**Technical Service
BULLETIN**

Title:
TICK NOISE AT BASE OF WINDSHIELD
Models:
'01 RAV4

REVISED
NVH
NV004-01

TSB Revision Notice:
The information on pages 3 through 6 has been added.

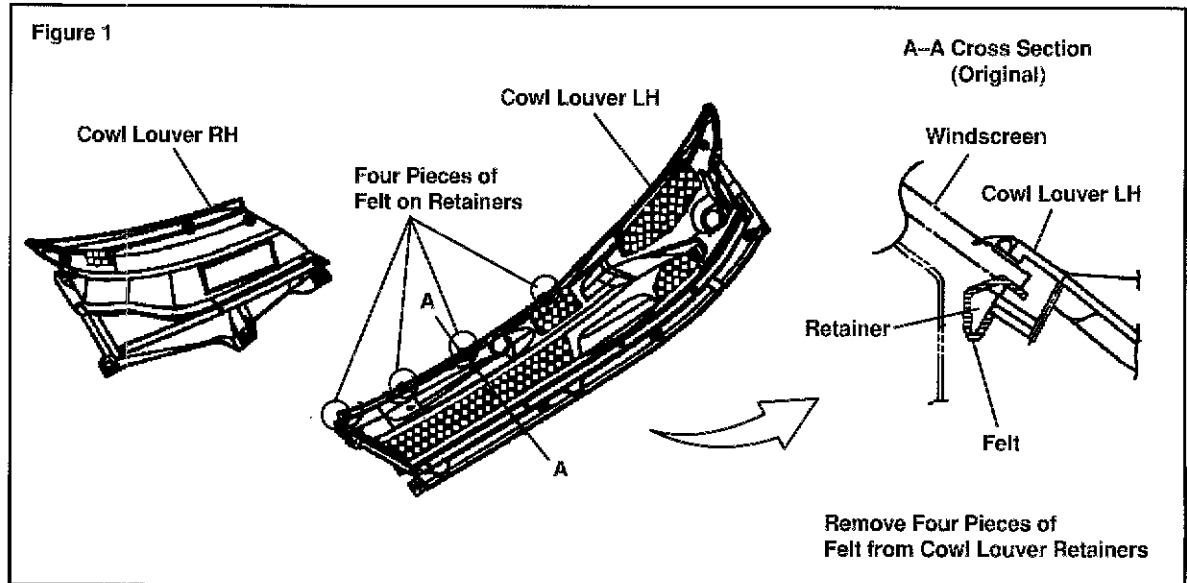
1. Determine root cause of noise (cowl louver or cowl panel). Remove the cowl louver as described below and re-confirm the customer's complaint with a test drive. If the noise is gone, perform the repair instructions pertaining to the cowl louver. If the noise is still present, perform the repair procedure for the cowl panel.
2. Remove both windshield wiper arms.
3. Remove RH cowl top ventilator louver/battery cover.
4. Remove driver's side (center) cowl top ventilator louver.
5. Remove the four original pieces of felt from the LH cowl louver retainers as shown in Figure 1.

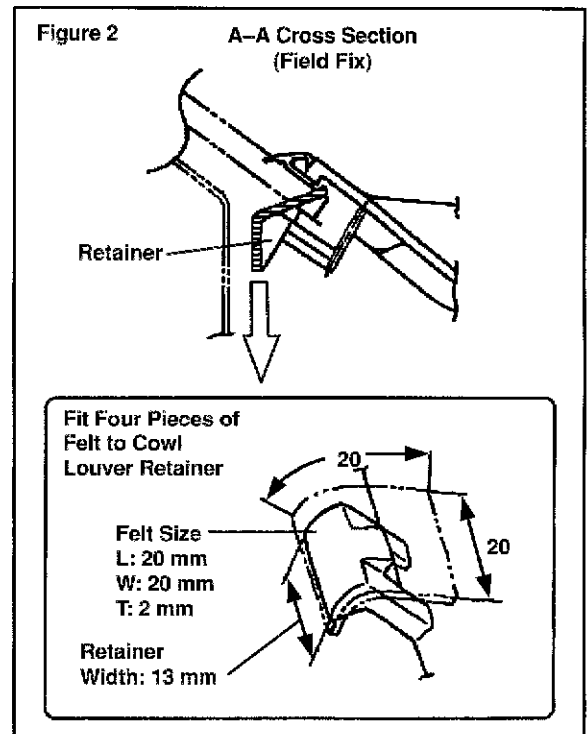
6. Cut four new pieces of felt to the dimensions shown below and apply them to the four retainers as shown in Figure 2.

Felt Size:
 Length: 20 mm
 Width: 20 mm
 Thickness: 2 mm

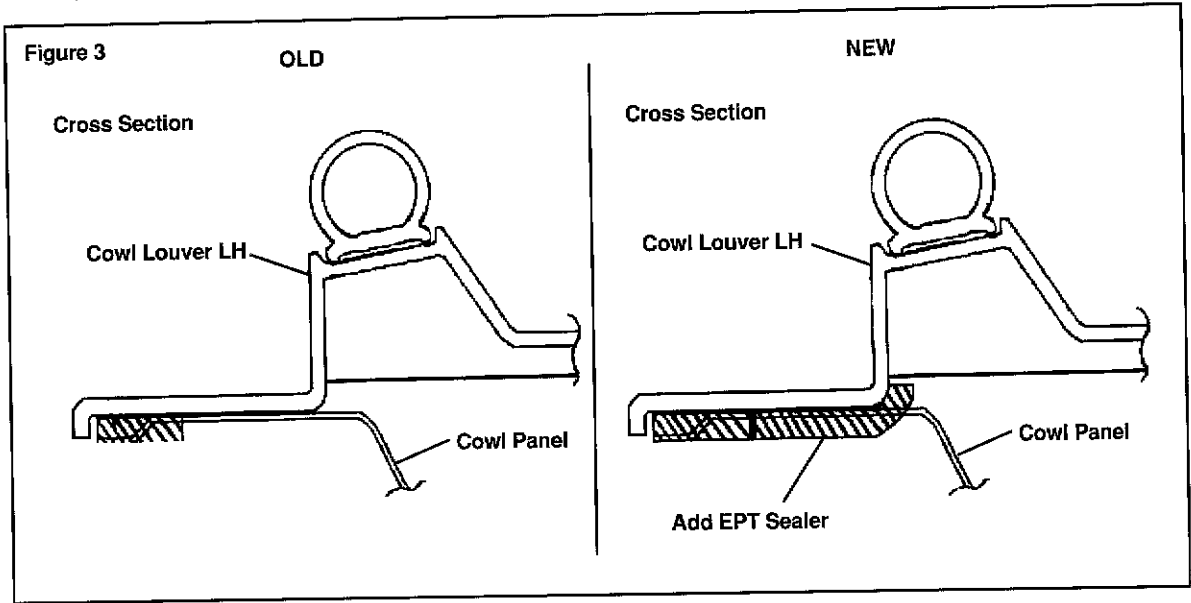
7. Add to the caulking sponge sealant (EPT sealer) applied originally to the center cowl top ventilator louver in the area shown in Figure 3.

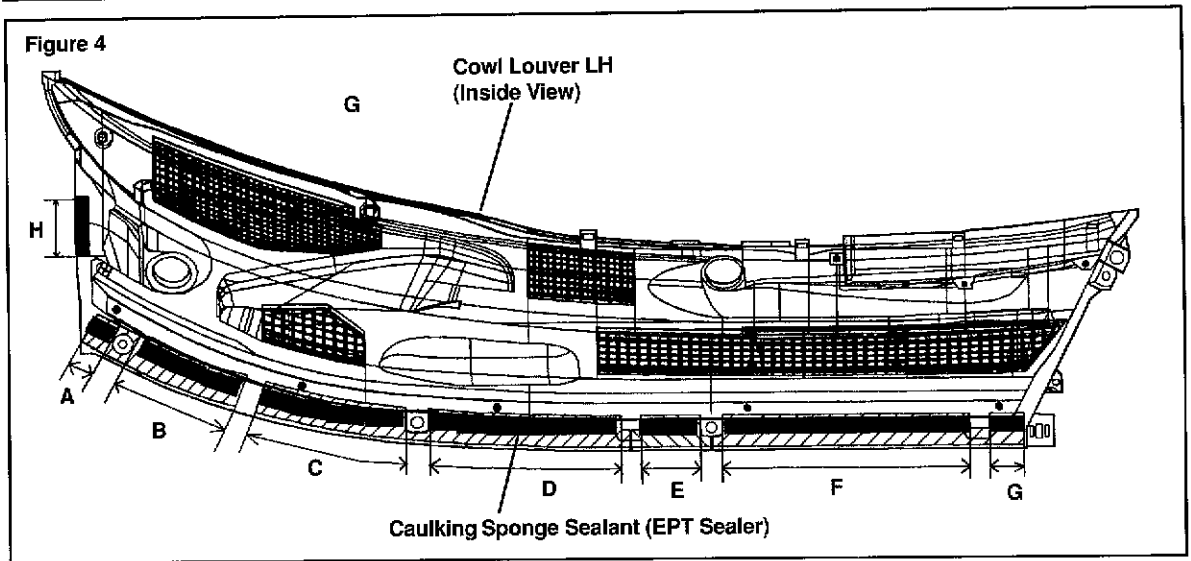
9. Apply the new strips of EPT sealer to the front of the cowl louver (See Figure 4).

8. Prepare eight new pieces of EPT sealer in the sizes shown in table below.

| LOCATION | A | B | C | D | E | F | G | H |
| Length | 30 mm | 110 mm | 145 mm | 180 mm | 50 mm | 230 mm | 15 mm | 54 |
| Width | 20 mm | 20 mm | 20 mm | 20 mm | 20 mm | 20 mm | 20 mm | 10 |
| Thickness | 3 mm | 3 mm | 3 mm | 3 mm | 3 mm | 3 mm <td 3 mm | 3 | |

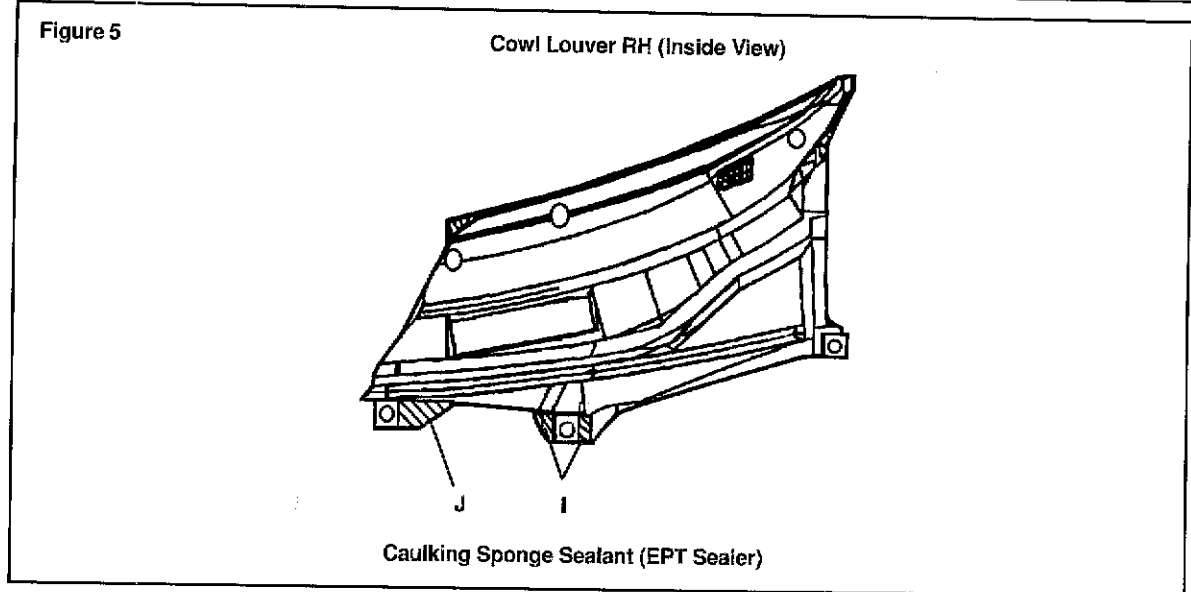
Prepare three more pieces of EPT sealer for the RH side cowl louver (covering the battery).

10. Trim the EPT sealer to match the shape of the cowl louver.

| LOCATION | I (2) | J |
| Length | 20 mm | 60 mm |
| Width | 10 mm | 30 mm |
| Thickness | 3 mm | 3 mm |

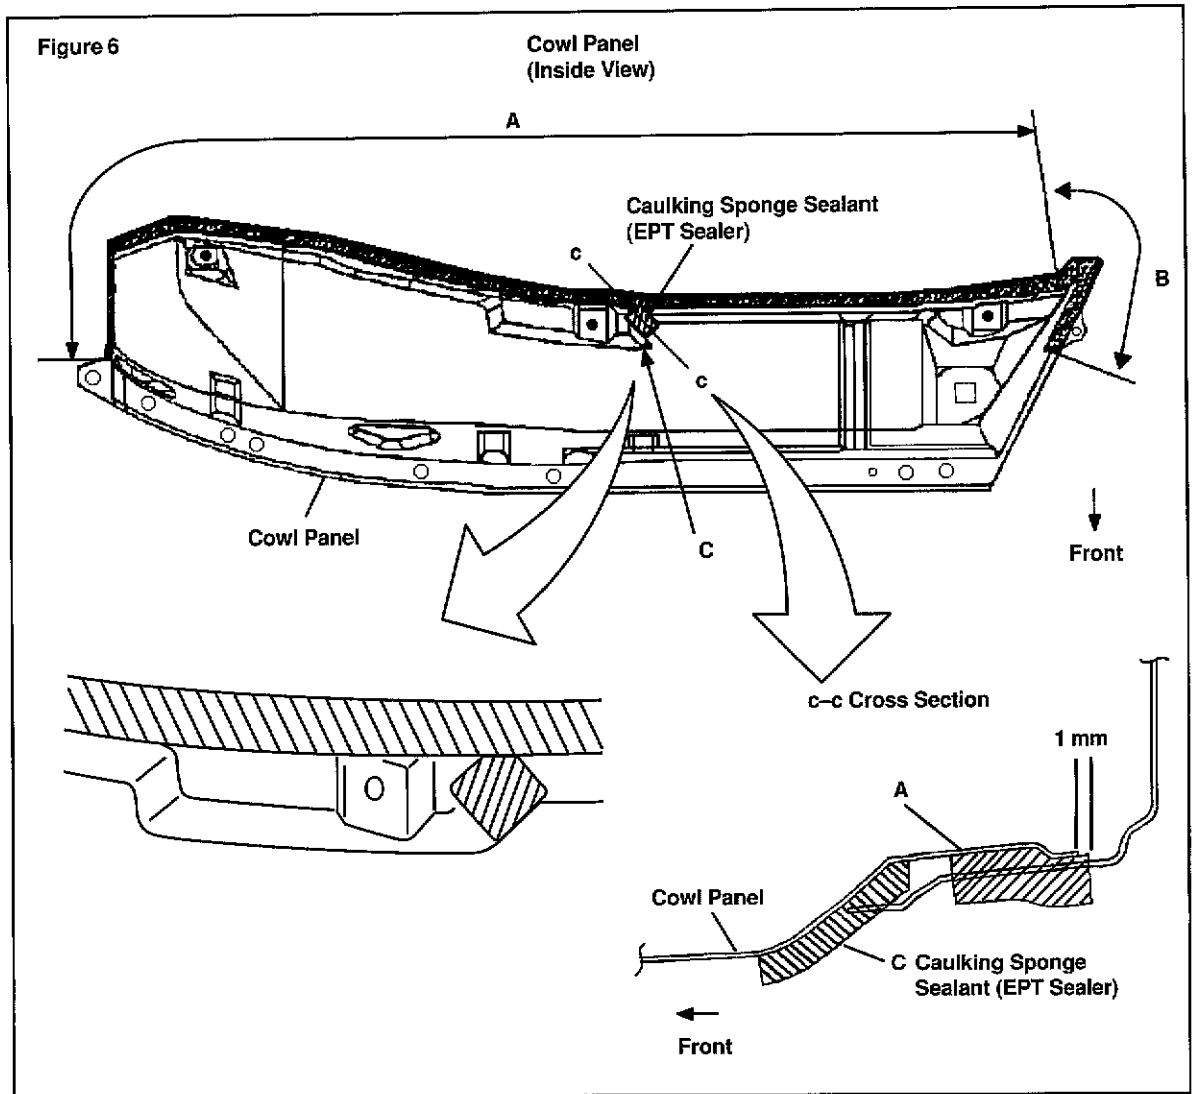
5. Make sure that the mating surfaces are clean and apply the new EPT sealer as shown below. Make sure that the EPT sealer hangs off of the edge of the panel by 1 mm while applying it to section "A".

| LOCATION | A | B | C |
| Length | 1190 mm | 230 mm | 30 mm |
| Width | 16 mm | 16 mm | 30 mm |
| Thickness | 10 mm | 10 mm | 5 mm |

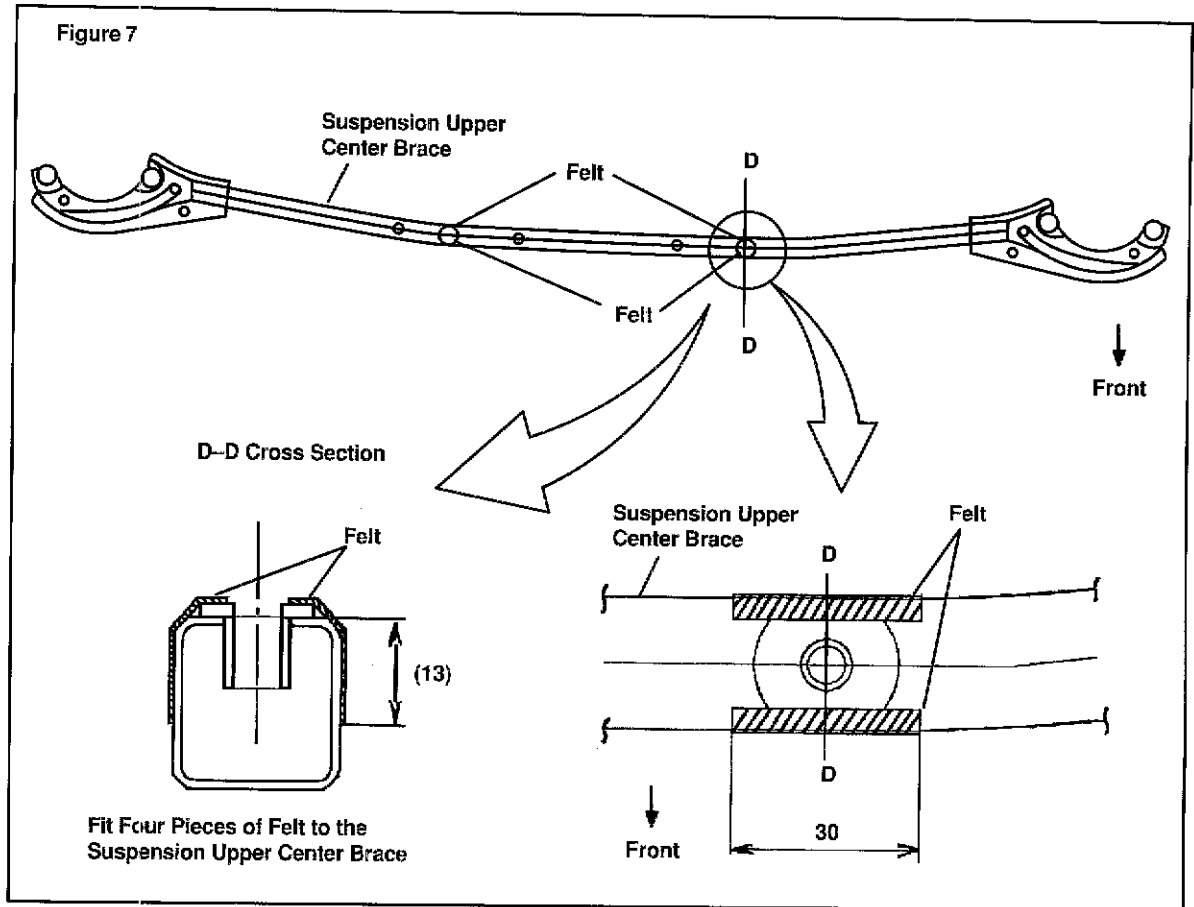
6. Before reinstalling the cowl panel add the four pieces of felt to the front suspension upper center brace as shown below.
Felt size:
Length: 30 mm
Width: 22 mm
Thickness: 0.5 mm
